Federal Register

14 CFR Part 39

[Docket No. 2004-SW-04-AD]

Airworthiness Directives; Bell Helicopter Textron Canada Model 222, 222B, 222U, and 230 Helicopters

Figure 1. Main Rotor Hub Assembly

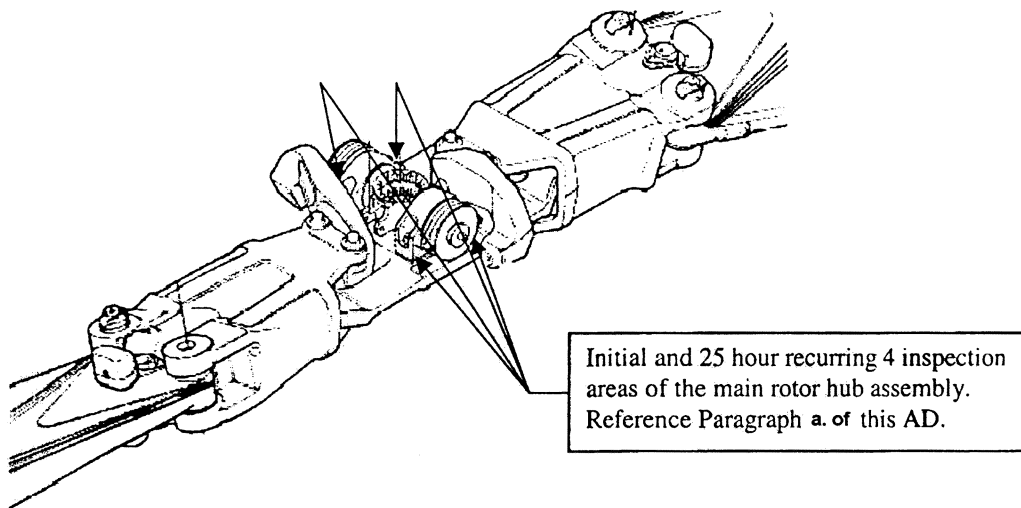
- (a) Within 50 hours time-in-service (TIS) or by the next scheduled inspection for the hub assembly, whichever occurs first, and thereafter at intervals not to exceed 25 hours TIS, using a 10X or higher magnifying glass, visually inspect the main rotor yoke (yoke)

for a crack, fretting or buffer deterioration in the four areas around the flapping bearing attachment bushings as shown in the following Figure 1 of this AD:
BILLING CODE 4910–13–P

(1) If a crack is found, before further flight, replace the yoke with an airworthy yoke.

Figure 2. Main Rotor Yoke

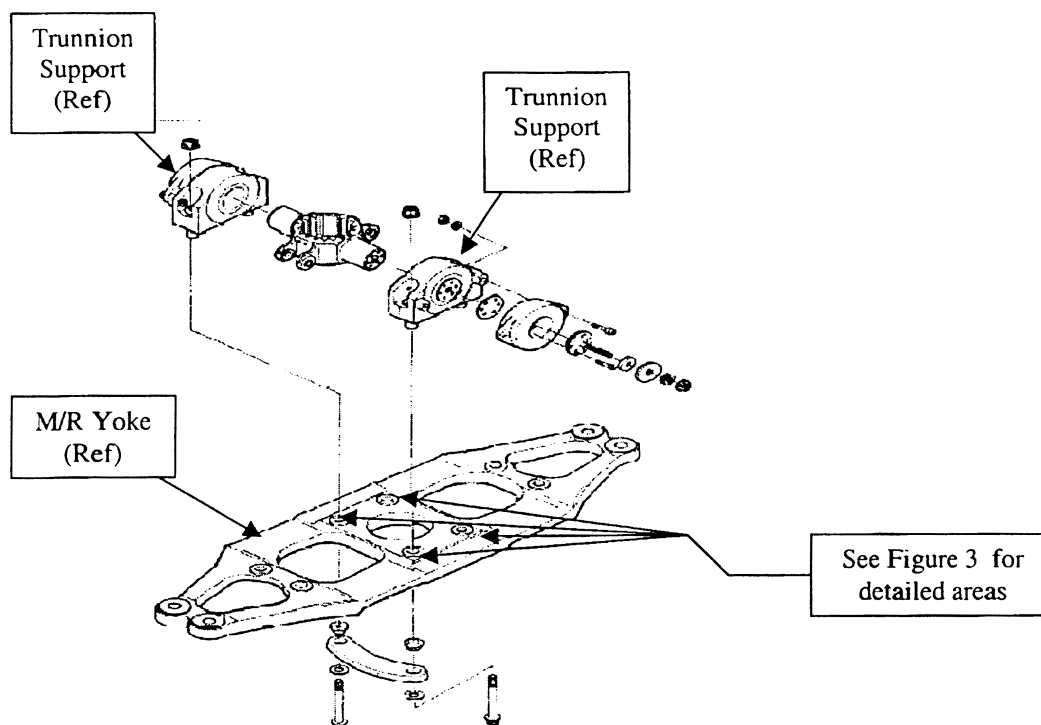
(2) If fretting or buffer deterioration is found on the yoke in the areas shown in Figure 1 of this AD, before further flight, disassemble the hub assembly and further inspect the yoke with a 10X or higher magnifying glass in the four areas shown in Figures 2 and 3 of this AD.

(i) If a crack is found on any part, before further flight, replace the part with an airworthy part.

(ii) If fretting or buffer deterioration is found on any part, before further flight, repair any unairworthy part or replace the part with an airworthy part.
